CALCULATOR SERVICE BULLETIN #L-510

MODEL: LA-7, LN, LNX

SUBJECT: Item Counter

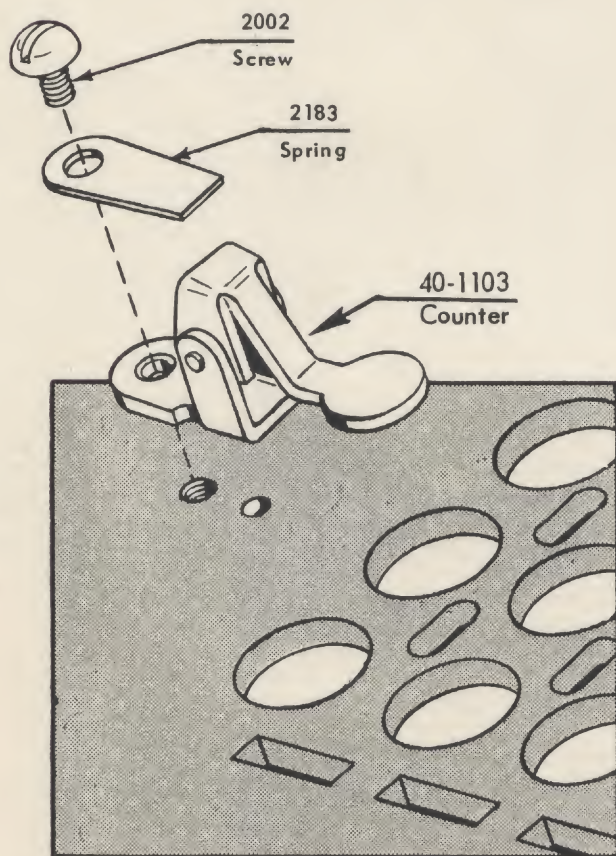
Installation will require the drilling of two holes in the keyboard supplementary plate as shown below.

#43 DRILL
(2 HOLES)

TAP 4-48
(1 HOLE)
3/16
